Project No: 2325-12	Ref: Huntly Quarry Managed Fill Sites 2-4 – Geotechnical S92 Response	Revision: A
----------------------------	--	--------------------

This letter is submitted in aid of a response to a request for additional information provided by the Waikato District Council under Section 92 of the Resource Management Act 1991. The section 92 request was provided by the council in the letter dated 18th December 2019. This letter is specifically in response to Point 1a under “Planning and General” and Point 4 titled “Geotechnical” as quoted below:

**HUNTLY QUARRY – FILL DISPOSAL SITES
SUMMARY REGISTER OF GEOTECHNICAL COMMENTS FROM PEER REVIEWER**

Project:	Huntly Quarry – Fill Disposal Sites
Subject:	Resource Consent Report

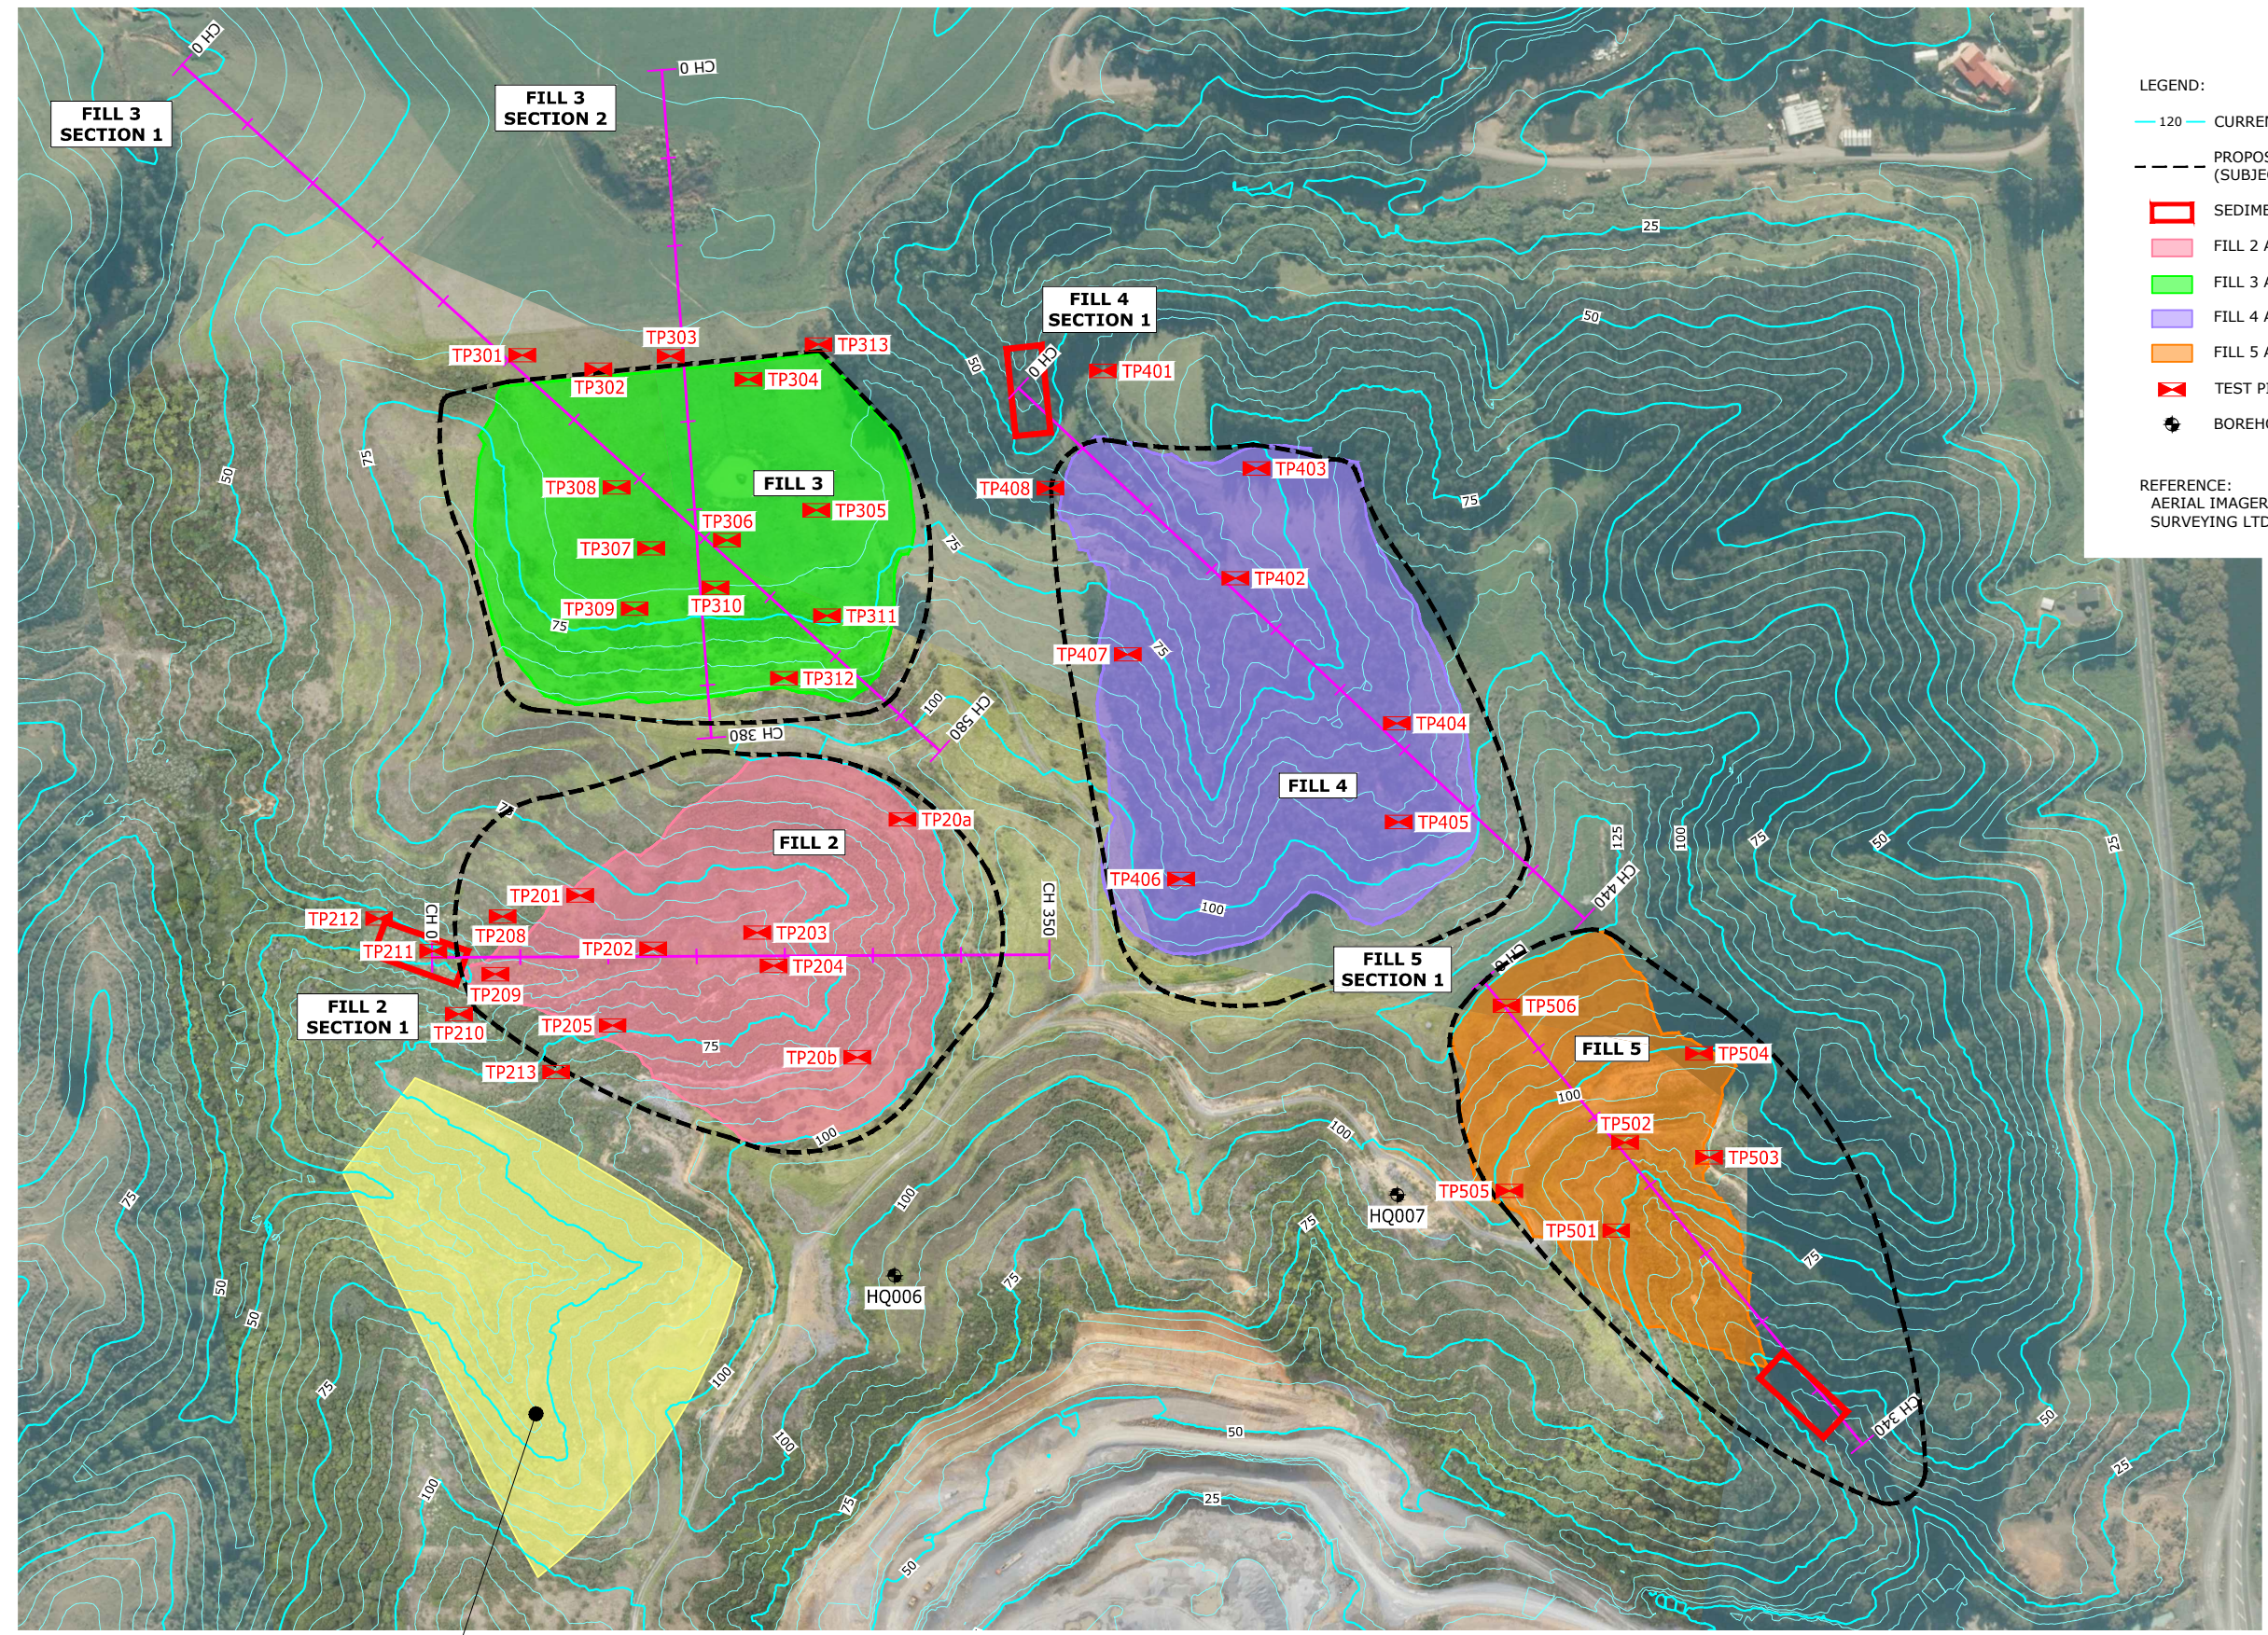
3	Groundwater	<p>Date (09/10/19)</p> <p>Influence of underlying groundwater conditions in the foundation soils on the stability performance of the fills.</p>	<p>Date (15/10/19)</p> <p>Surficial groundwater regimes are currently heavily influenced by the presence of farm dams, ponds, infilled gullies etc. As such, we have recommended that these dams and ponds be released and drainage measures installed. Subsequent groundwater conditions will be reassessed. It is anticipated that this would happen post Resource Consent and during detailed design and construction stages</p>		<p>Date (03/11/19):</p> <p>We are comfortable with what is proposed. A reasonable assumption around foundation groundwater pressures in line with proposed drainage works will need to be made in analyses discussed in 2. Above.</p>	<p>Date (07/11/19):</p> <p>Noted. See point 2.</p>	<p>Comment Closed Out</p>
9	Fill Extents	<p>Date (09/10/19)</p> <p>Extent of fill footprint not finalised at this pre-application stage will need to</p>	<p>Date (15/10/19)</p> <p>It is our understanding that the concept fill footprints provided by our client are representative of the required fill. From</p>		<p>Date (03/11/19):</p> <p>We understand that during construction deviations in places may need to be made. The proposed</p>	<p>Date (07/11/19):</p> <p>Please see revised drawing included in Appendix A of the Rev. C report.</p>	<p>Comment Closed Out</p>

No.	Element	Peer Reviewer Comment Description	Gaia Response	Closed Out (Y/N) Comment	Further Reviewer Comment	Gaia Response	Closed Out (Y/N) Comment
		be confirmed prior to consent application	discussion with our client we understood that it is desirable to maintain a scope to deviate slightly from the concept footprints where required during the detailed design stage. These deviations are largely for operational reasons and are unlikely to be significant from a geotechnical perspective. We propose that a "Footprint Limit" or similar be added to the concept drawings to aid with visualisation of this.		footprint limit would assist our understanding of the anticipated extent of the deviations that may occur.	The fill footprints are all confined to the gully they reside in. Comment has been added to Section 8.4 of the Rev C report to discuss this.	
11	Whole-of-life considerations	Date (09/10/19) Consideration for in-ground pore water pressure monitoring such as vibrating wire piezometers to be installed within the fill.	Date (15/10/19): In our experience with similar fills a sufficient approach has been to monitor settlement and displacement of the fills with sufficient placement of designed drainage blankets to speed up fill consolidation as each bench is completed. We propose installation of standpipe piezometers or similar as a mitigation strategy should unsatisfactory settlement/displacement be observed within the fills. Settlement and displacement vs time thresholds will be developed for each fill during detailed design.		Date (03/11/19): While monitoring of pore pressure build up in the fill would assist in managing global instability risk, the proposed drainage blankets are largely expected to adequately control this. Having given this further consideration, we are comfortable with the monitoring proposed by Gaia.	Date (07/11/19): Noted, thank you.	Comment Closed Out

PROPOSED FILL 2 SECTION 1
SCALE 1:1000 (A3)

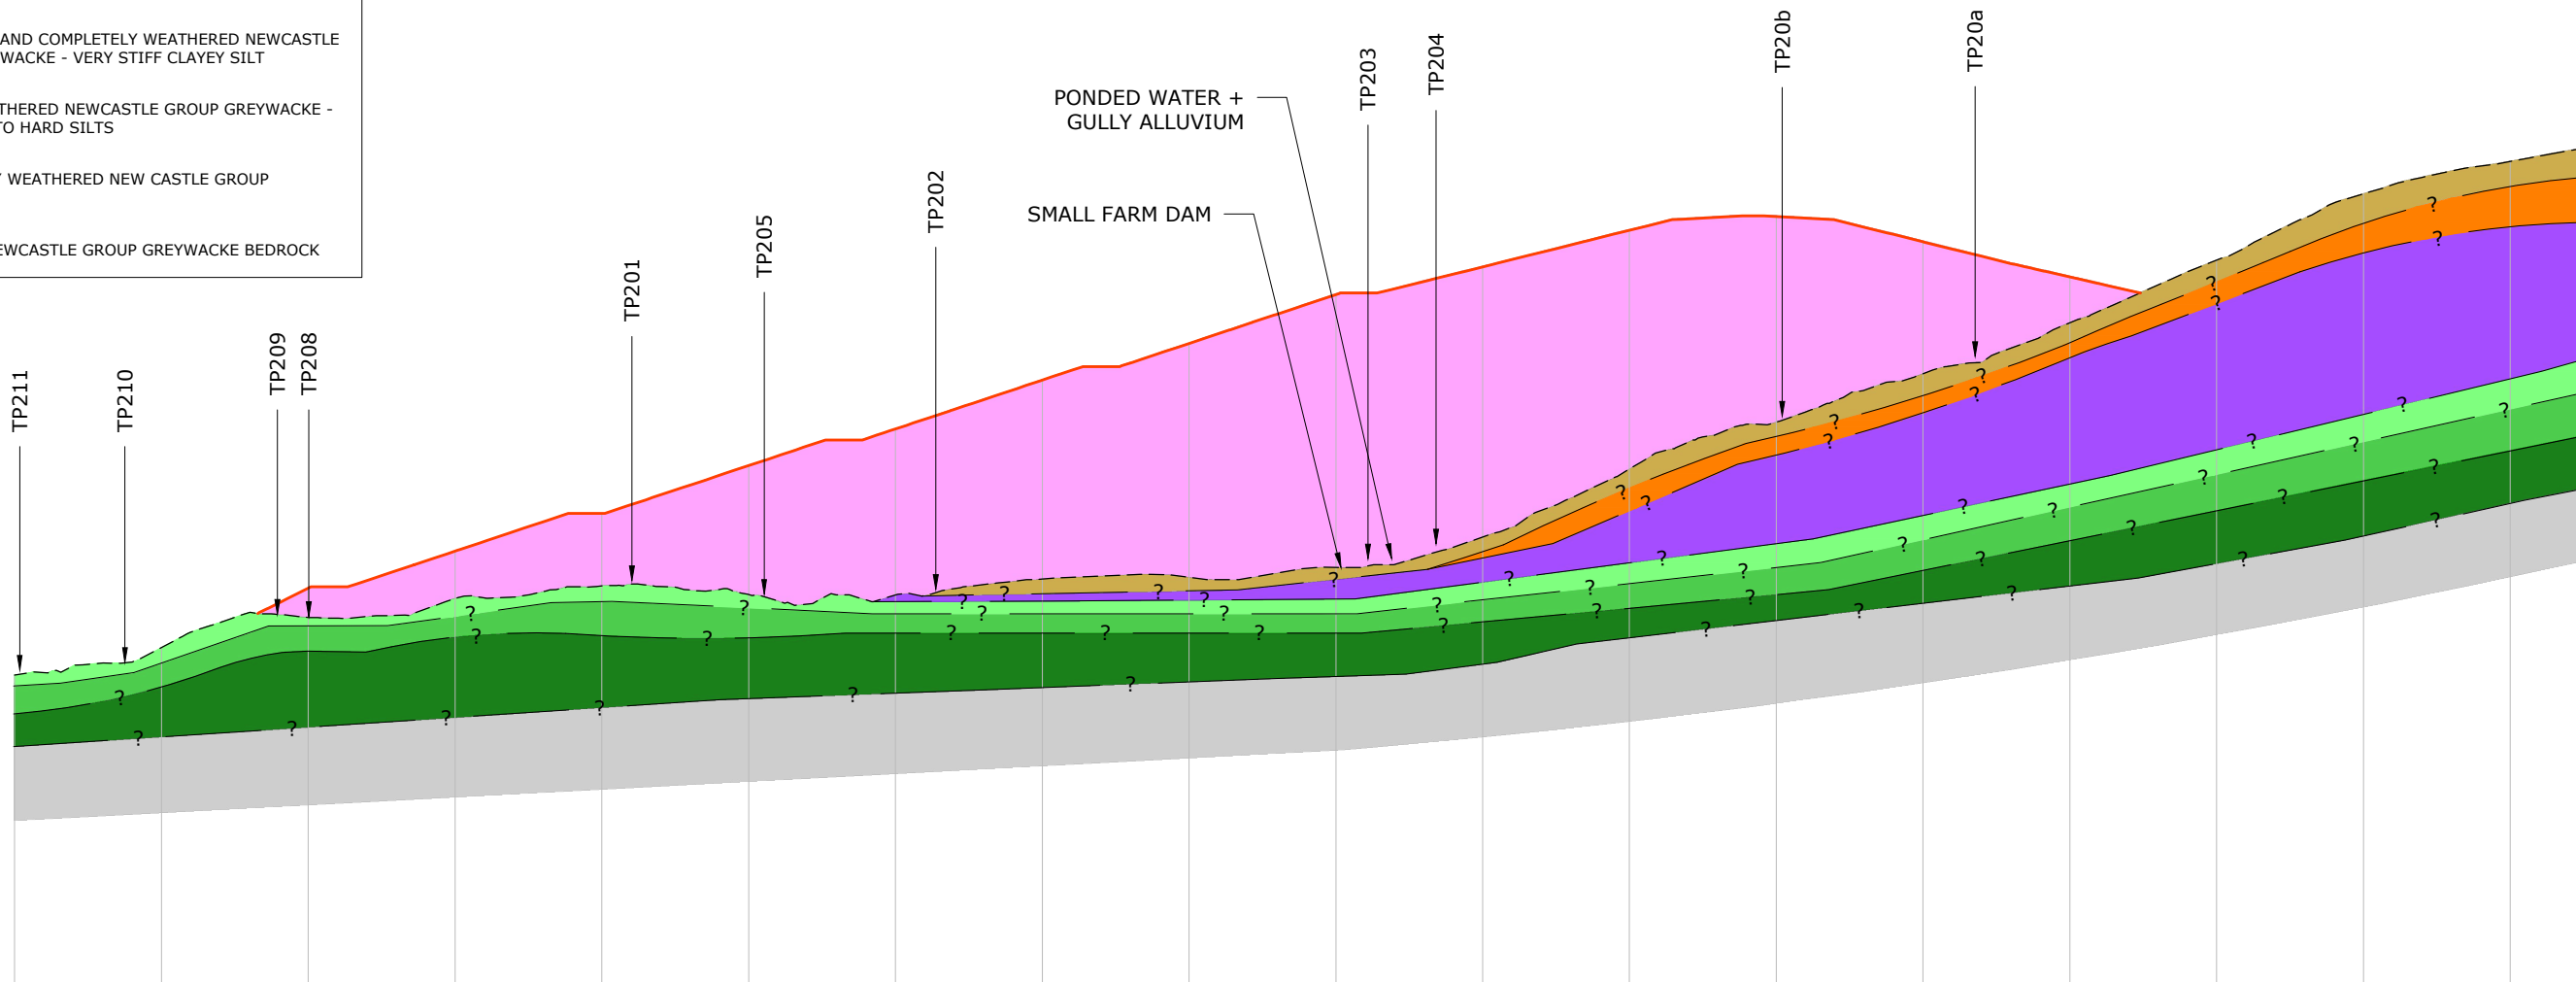
3. Revised Fill Site 2 Geology

As part of the ongoing detailed investigation and design works for Fill Site 2 at the Huntly Quarry, additional investigation near the toe of the proposed fill has since been carried out.

The additional test pits encountered improved ground conditions over those initially used for concept stability calculations. The improved ground conditions comprise weathered greywacke soils of the Newcastle Group in place of the previously assumed Waikato Coal Measures. Weathering depth to weak highly weathered material was found to be within 1.5m of the surface near the invert of the gully such as in TP209 and TP211.

Revised slope stability calculations based on the weathered greywacke toe founding material as opposed to the original Waikato Coal Measures toe founding material are provided in Appendix D.
